Department of Energy
Carlsbad Field Office
P. O. Box 3090
Carlsbad, New Mexico 88221

Subject: Response to EPA May 20, 2004 Letter on CRA

In response to the Environmental Protection Agency's (EPA's) letter of May 20, 2004, and the request for information received during the EPA Run Control Inspection the Week of August 9, 2004, the U.S. Department of Energy (DOE) is providing information to answer the questions included in the enclosure to that letter and answer the inspection information request.

Figure 1. Comparison of SANTOS and SPECTROM-32 Results for Three Different Gas Generation Rates.

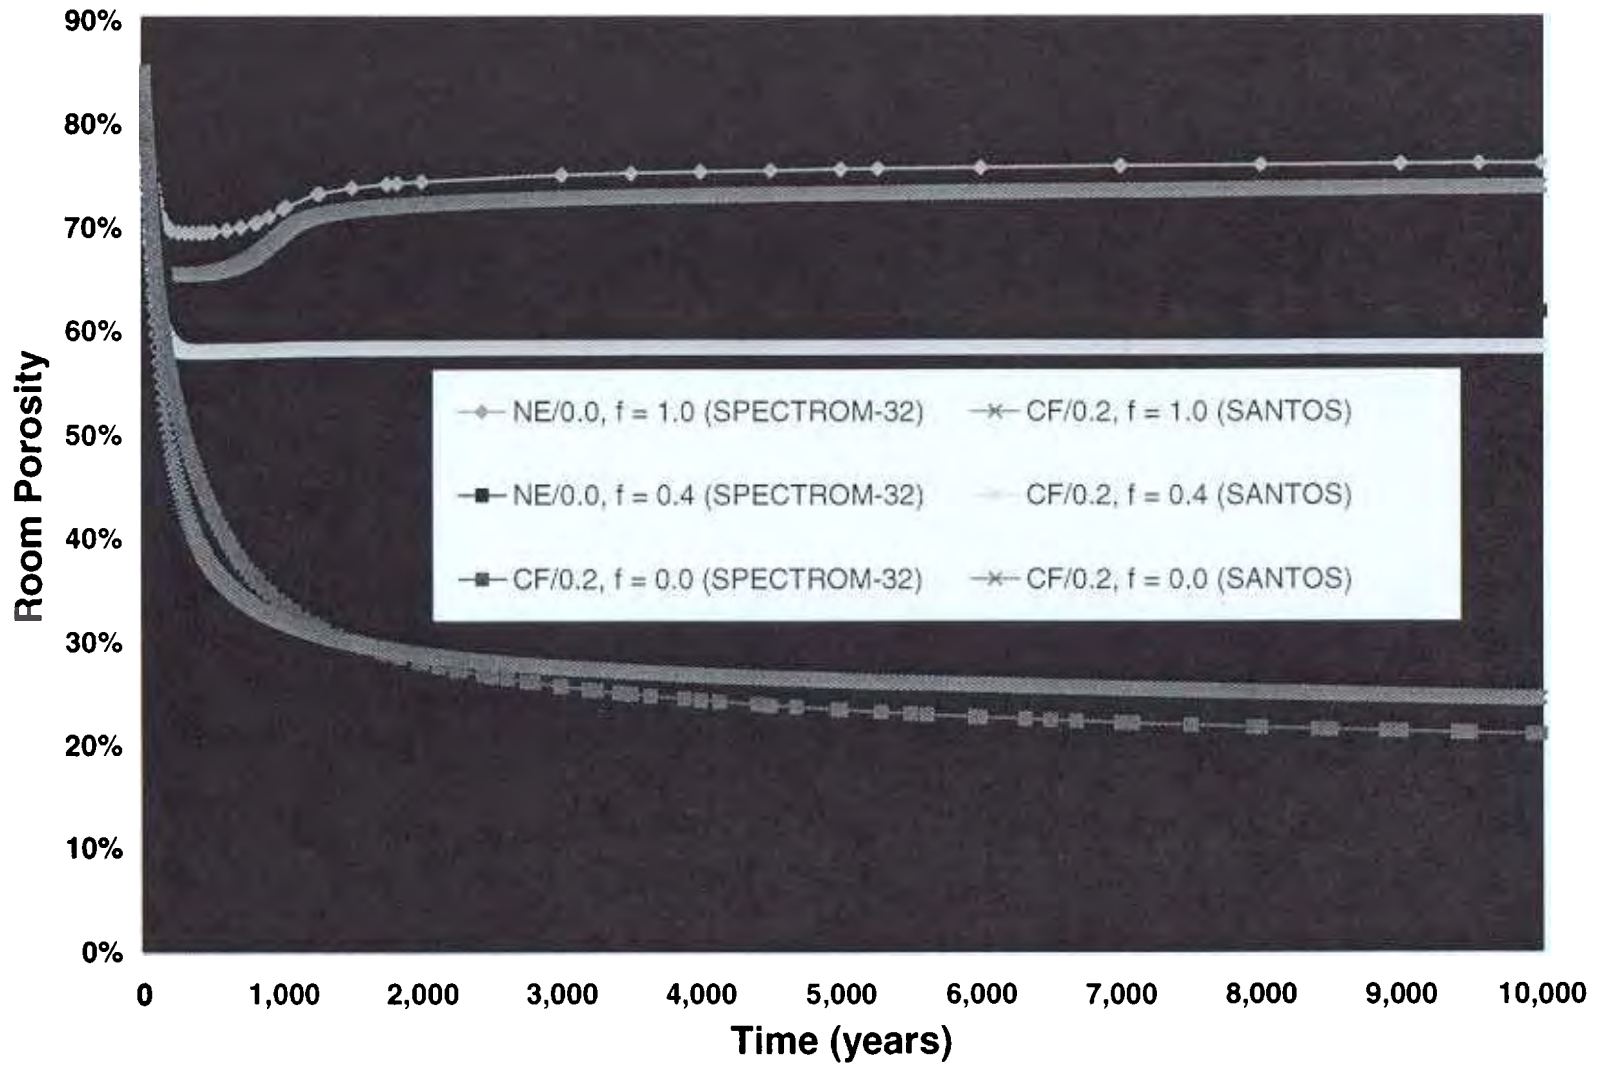
We stated in our preliminary PA code review, completed in June 2003 (Docket Number: A-98-49, ILB3-70):

"After completing the Agency's review, the EPA has concluded that 36 (of the 39) computer codes and three libraries migrated to the Compaq ES45 and 8400 with OpenVMS 7.3-1 are approved for use in compliance calculations for the WIPP performance assessment. Final technical review of the remaining three codes (e.g., NUMBERS, SANTOS, DRSPALL) will be conducted separately as part of the Agency's review and evaluation of the CRA. Specifically, the EPA will ensure that:

- 1. DRSPALL, 1.0 is regression tested on the Compaq ES45 and 8400;*
- 2. NUMBERS meets the QAP 19-1 requirements; and*
- 3. SANTOS is properly evaluated for accuracy."*

Figure 1 compares the average room porosity results obtained from SPECTROM-32 and SANTOS for three different problems. Figure 1 uses the following abbreviations:

Figure 1 compares room porosity results obtained with SPECTROM-32 and SANTOS for gas generation rates (f) of 0, 0.4, and 1. For the case with no gas generation, the SPECTROM-32 porosity results are slightly higher than the SANTOS results earlier in time and slightly lower than the SANTOS results later in time. At 10,000 years, the SPECTROM-32 and SANTOS results differ by about 3.4% room porosity (i.e., 20.9% versus 24.3%). For the gas generation cases ($f = 0.4$ and $f = 1.0$), the SPECTROM-32 results were computed using a nonlinear elastic model for the TRU waste with a Poisson's ratio of zero; whereas, the SANTOS results were generated using the crushable foam model for the TRU waste with a Poisson's ratio of 0.2. Despite these TRU waste model differences, the SPECTROM-32 and SANTOS room porosity results are quite similar with the SPECTROM-32 results being consistently higher than the SANTOS results. At 10,000 years, the SPECTROM-32 ($f = 0.4$ case) result is about 3.4% room porosity higher than the SANTOS result (i.e., 61.7% versus 58.3%). At 10,000 years, the SPECTROM-32 ($f = 1.0$ case) result is about 2.2% room porosity higher than the SANTOS result (i.e., 76.0% versus 73.8%).

Figure 1. Spallings Releases Calculated Using the Average Radioactivity Over All CH-TRU Waste Streams

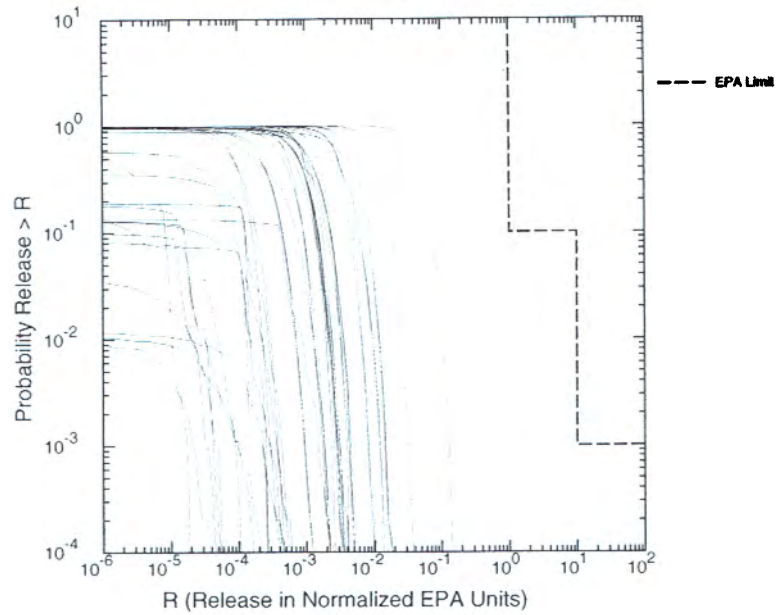
The CRA states that “spallings are assumed to be derived from a sufficiently large volume of waste that container-scale variability can be neglected.” While we accepted this assumption in the original certification decision, since then DOE has used a number of different container configurations-such as ten drum overpacks and supercompacted waste-with greater frequency than estimated earlier. In addition, the new DRSPALL code generally predicts much lower release volumes. For these reasons, neglecting container-scale variability may not be a valid assumption.

DOE must fully justify the existing waste spall model given the changes in waste container since the CCA and the new spallings model results or must rerun the CRA PA with assumptions that better reflect the container variation.

Figure 1 shows the 100 complementary cumulative distribution functions (CCDFs) for CRA Replicate 1 spallings releases that were computed using the average radioactivity across all CH waste streams. Fifty-eight of the 100 vectors fall off-scale with values too low to plot. Figure 2 shows the 100 CCDFs for CRA Replicate 1 spallings releases that were computed using the randomly sampled waste streams. Fifty-seven of the 100 vectors fall off-scale.
